D350-748-243TRN
Job Sheet 191011

Part Name: Crosstube Installation, High Aft

DART AEROSPACE LTD HAWKESBURY, ONTARIO, CANADA	
DRAWING NO. D350-748-243	REV. A SHEET 1 OF 4
TITLE CROSSTUBE (AS 350/355 HI AFT)	SCALE NTS
COPYRIGHT © 2015 BY DART AEROSPACE LTD THIS DOCUMENT IS PRIVATE AND CONFIDENTIAL AND IS SUPPLIED ON THE EXPRESS CONDITION THAT IT IS NOT TO BE USED FOR ANY PURPOSE OR COMMUNICATED TO ANY OTHER PERSON WITHOUT WRITTEN PERMISSION FROM DART AEROSPACE LTD.

DRAWING NO. D350-748-243	TITLE CROSSTUBE	REV. A	DART AEROSPACE LTD ENGINEERING ORDER		D.E.O. NO. D350-748-243-A-1	SHEET NO. SHEET 1 OF 1	SCALE NTS
DRAWN <i>qp</i>	CHECKED <i>ASS</i>	MFG. APPR. <i>[Signature]</i>	APPROVED <i>[Signature]</i>		DE APPR. <i>[Signature]</i>		
DATE 15.11.18	DATE 15.11.18	DATE 14.02.19	DATE FEB 19 2016		DATE 2016.02.19

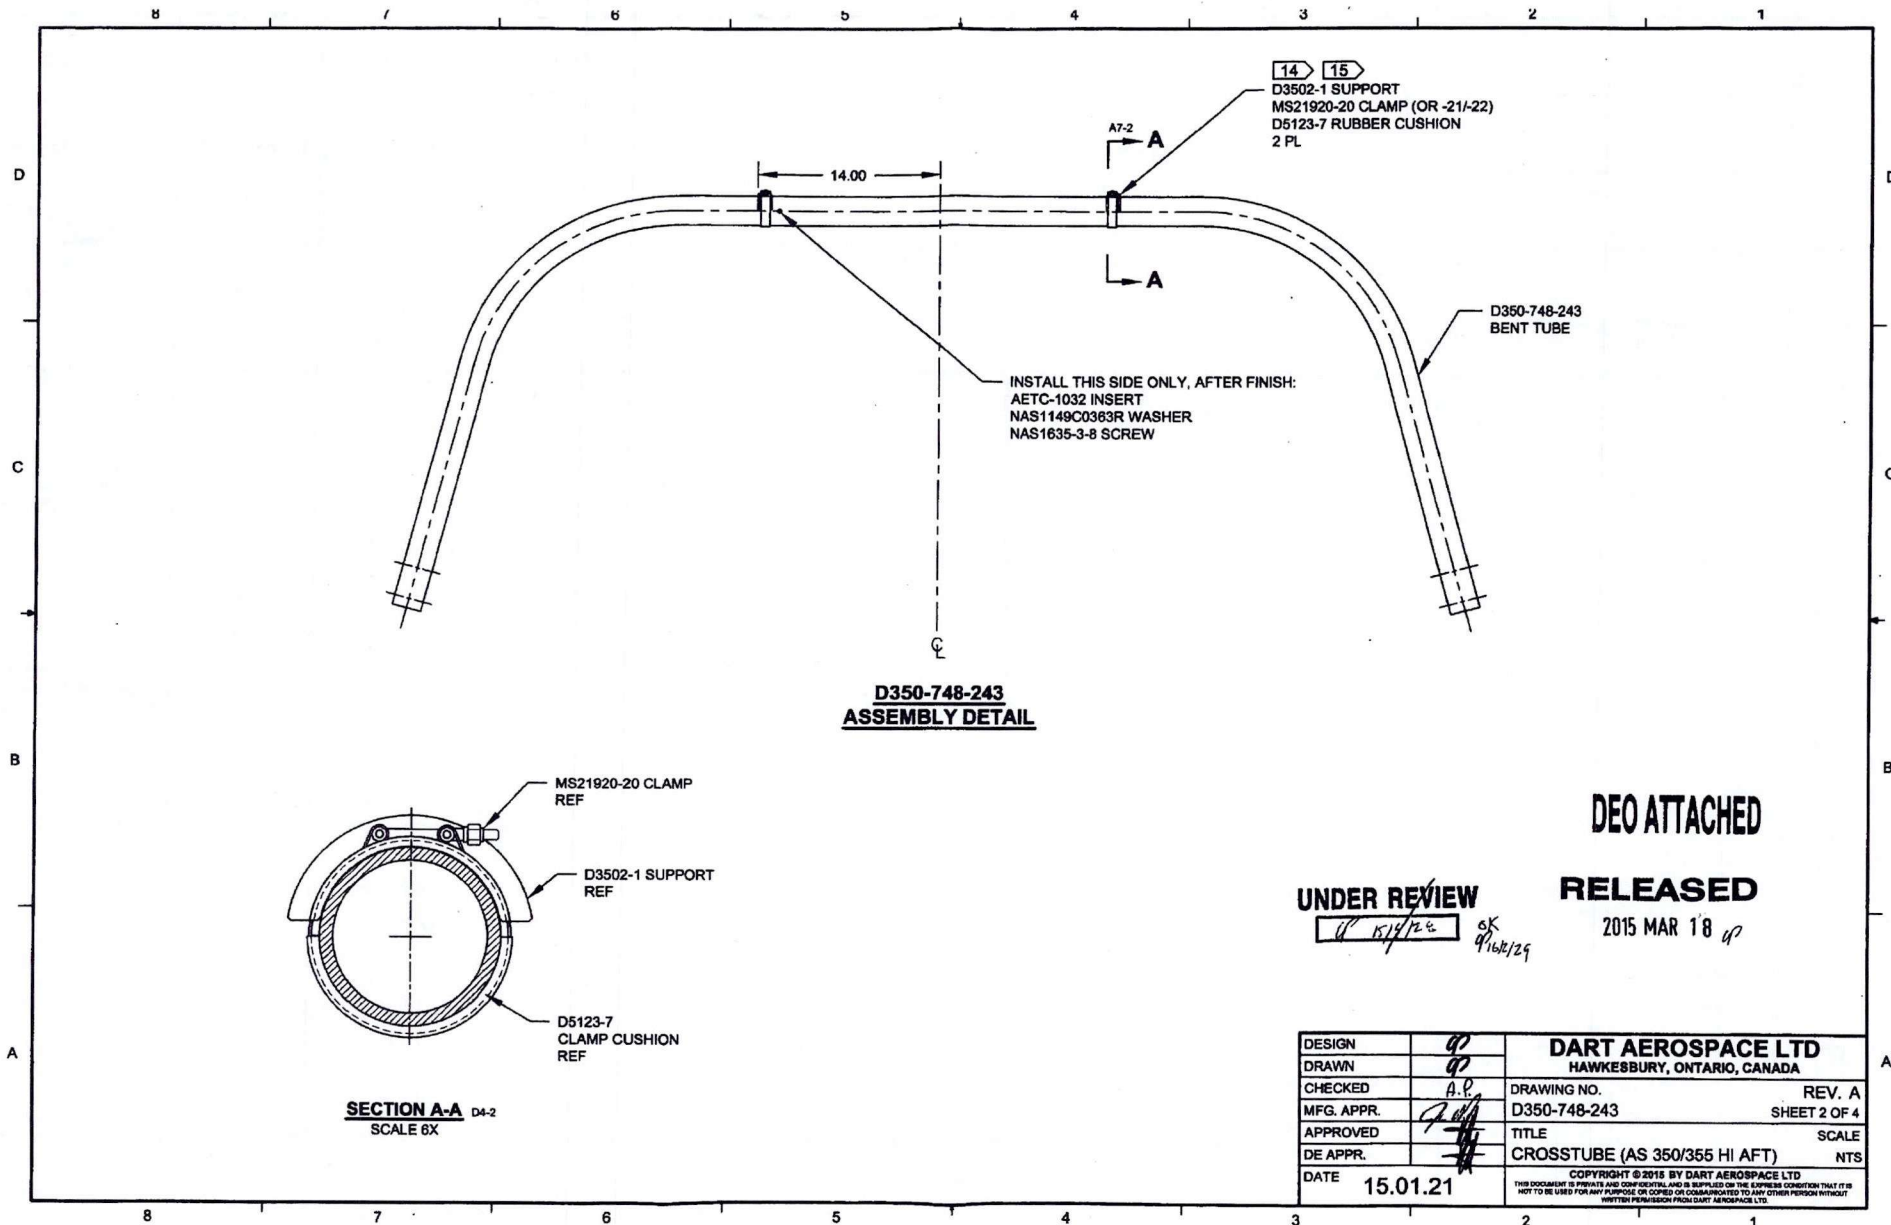
AMEND NOTE 2 (SHEET 1) AS FOLLOWS:

- 2) FINISH: PREPARE SURFACE PER DART QSI 005 4.1.4
 PRIME INSIDE AND OUTSIDE PER DART QSI 005 4.2
 PAINT OUTSIDE PER DART QSI 005 4.2
 OR
 POWDER COAT WHITE (4.3.5.2) PER DART QSI 005 4.3
